Serial No. 10/064,752

Amendments to the Drawings

REMARKS

Fig. 1

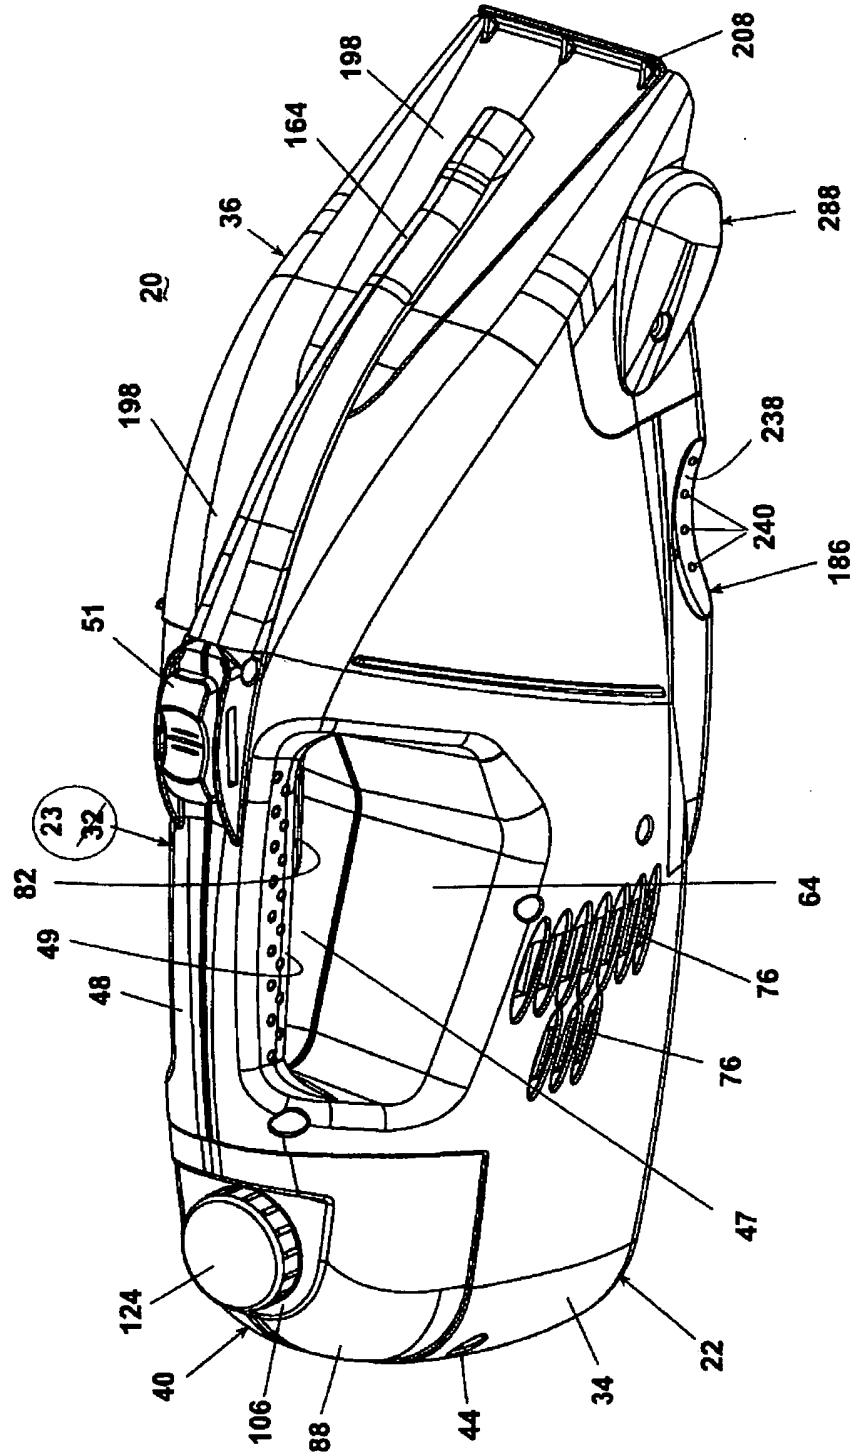
The attached sheets of drawings include changes to FIGS. 1, 2, 3, 4, 17, and 26. These sheets replace the original sheets including FIGS. 1-4, 17 and 26.

By the present amendment, the specification and drawings have been amended to overcome the objections raised by the Examiner in the Office Action. The Examiner's thorough review of the specification and drawings is appreciated. With respect to the Examiner's objections with respect to numerals 217, 214, 221, and 38 as appearing in paragraph 8 of the Office Action, the numerals 217, 214, and 221 are found in FIG. 3 and number 38 is found in FIG. 2. Further, with respect to the Examiner's objection with respect to page 17, paragraph 92 "through an 314," the passage in the specification reads "through an opening 314".
